Subject: Palo Verde Nuclear Generating Station  
(PVNGS) Units 1, 2 and 3  
Docket Nos. STN-50-528/529/530  
File: 81-056-026

Reference: Your letter of June 17, 1981, Subject:  
Draft SER Input, AC Power Systems

Please find attached our responses to the open items identified in your letter. Also attached is a marked-up copy of the FSAR sections referenced, as they will be incorporated in a future amendment.

A- 50004.1

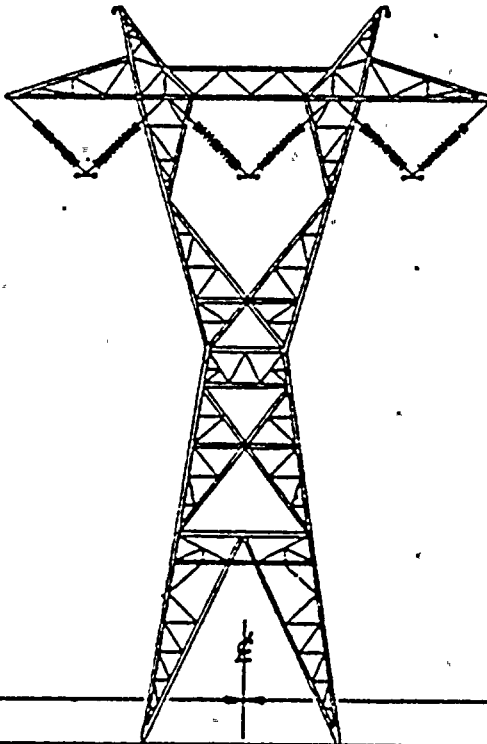
1. A discussion of transmission line right-of-ways, height as well as spacing between transmission towers, etc.
2. Physical layout drawings of the circuits that connect the on-site distribution system to the off-site power system.
3. A description of the instrumentation provided for monitoring and indicating the status of the off-site power system and switchyard batteries.

1. Overall map showing the Transmission System 500kV lines.
2. Drawing K-675-503. Palo Verde/Kyrene line route map.
3. Bechtel Drawings 13-E-ZYP-012; ZVU-009 & 13-C-ZVA-001 showing line routing on the plant property.
4. Typical tower, pole and double tower right-of-way usage.

The plan and profile sheets for the Palo Verde/Kyrene line show the double right-of-way obtained for a portion of the line length for a future Saguaro line. Right-of-way acquisition beyond this common corridor has not yet been acquired.

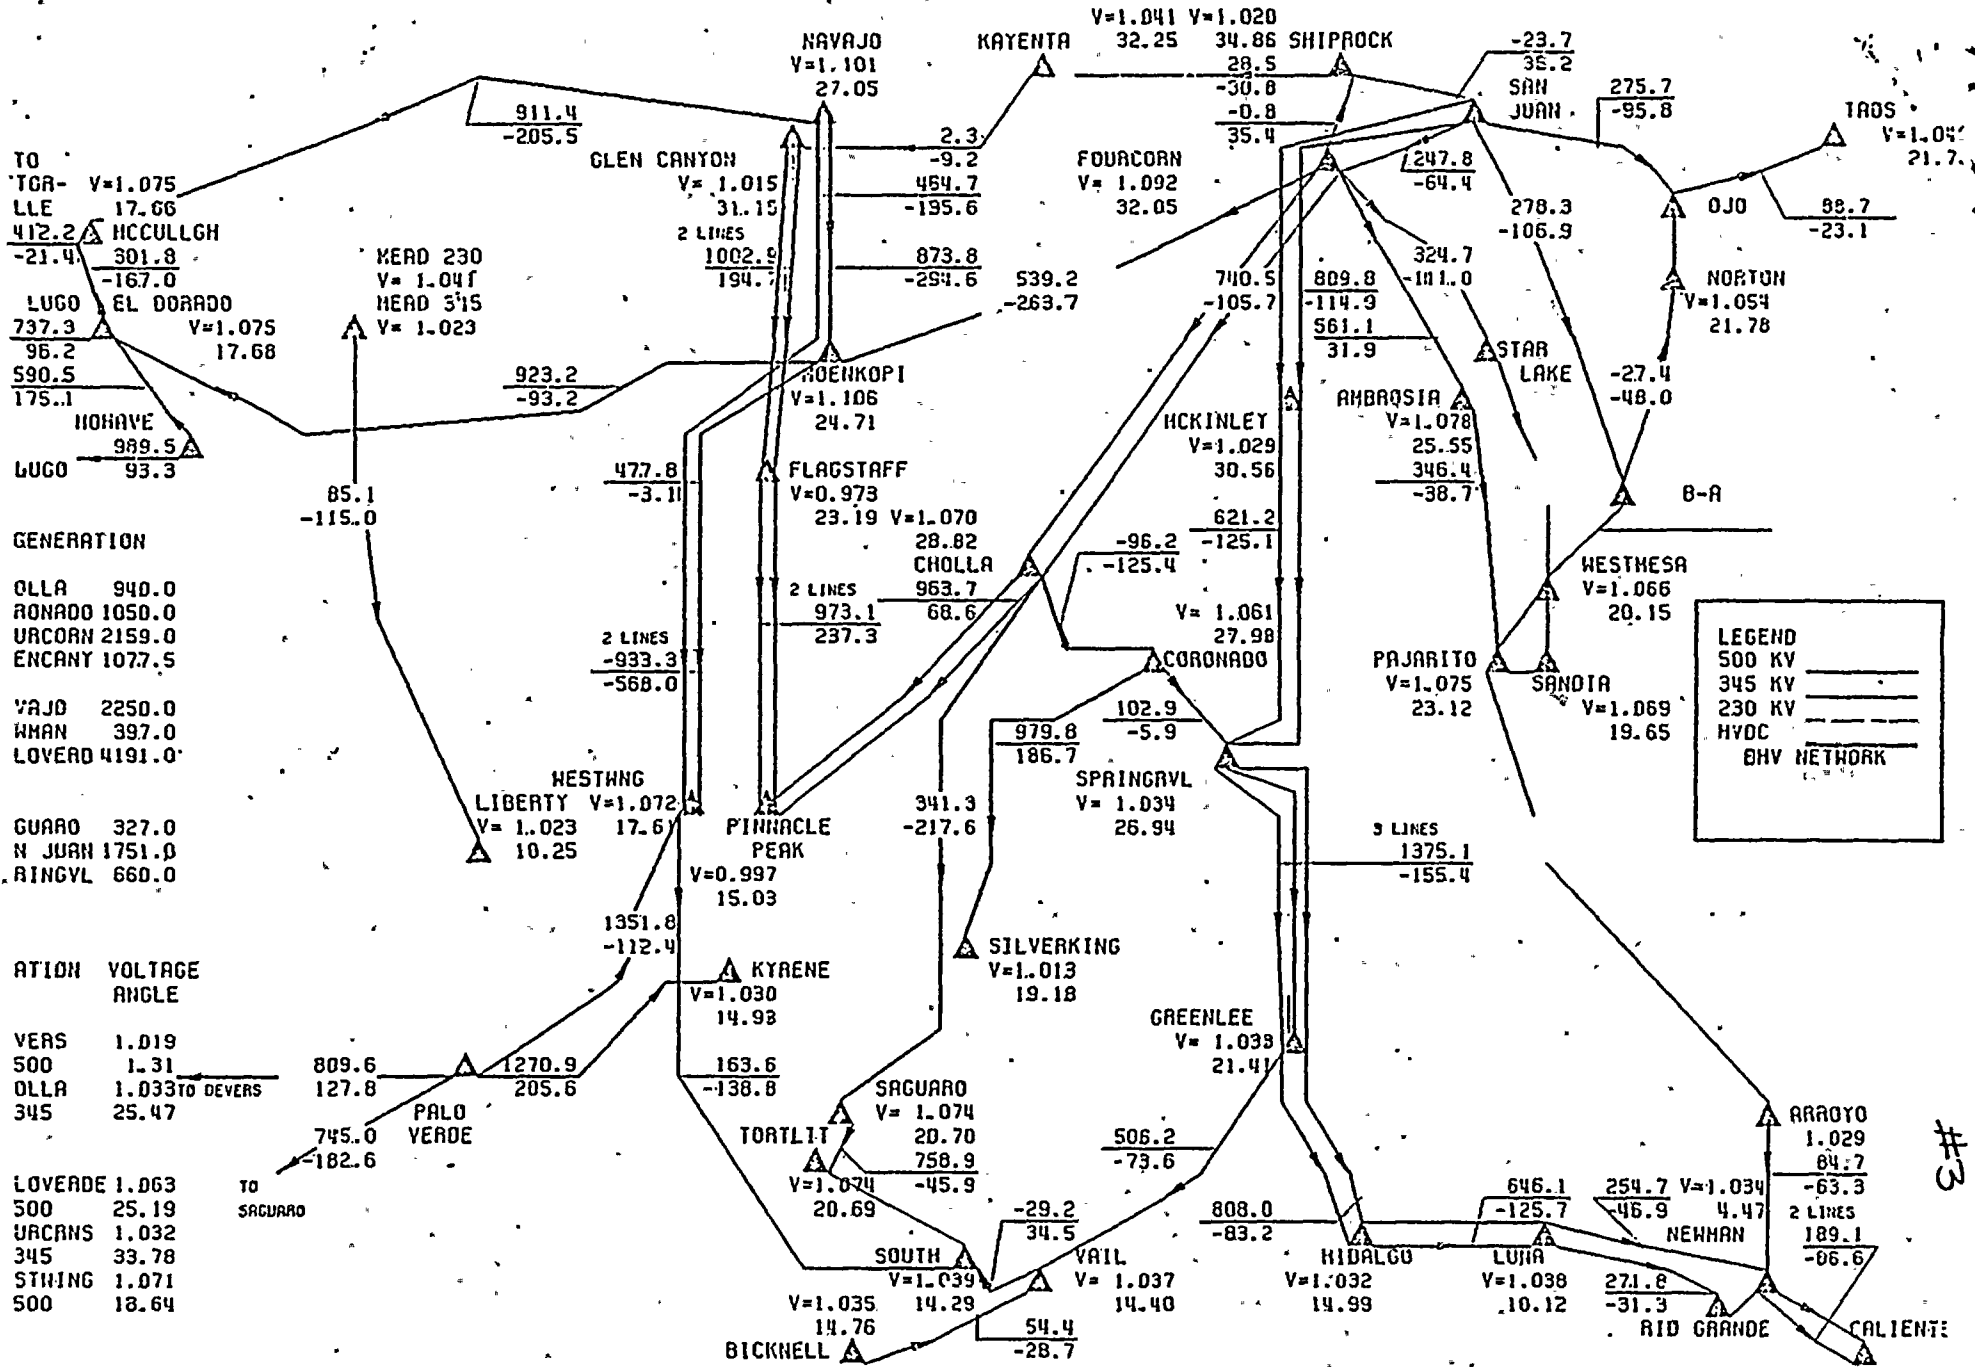
Provide the transmission load flow diagram associated with the transient stability cases assumed in the FSAR.

RESPONSE: The load flow diagram has been submitted to the NRC.
